# Technical product information

Topic	8 speed transmission - front differential noi					
Market area	Worldwide Bentley (1WBE)					
Brand	Bentley					
Transaction No.	2032542/1					
Level	EH					
Status	Approval					
Release date

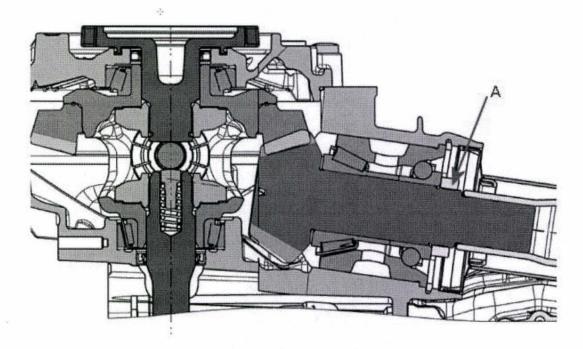
A small number of 8 speed transmissions have developed a front differential noise in service. Subsequent investigations of these replaced units identified a reduction in the torque of the nut (A) retaining the front differential bevel gear bearing. Front differentials where the clamping load on this bearing has relaxed will become noisy and have a greatly reduced service life

The surface finish and method of locking the bevel gear bearing retaining nut has been changed

As the front axle final drive unit is not serviceable and is integral with the main transmission assembly a qualified complaint of this nature can only be rectified by fitting a new transmission assembly.
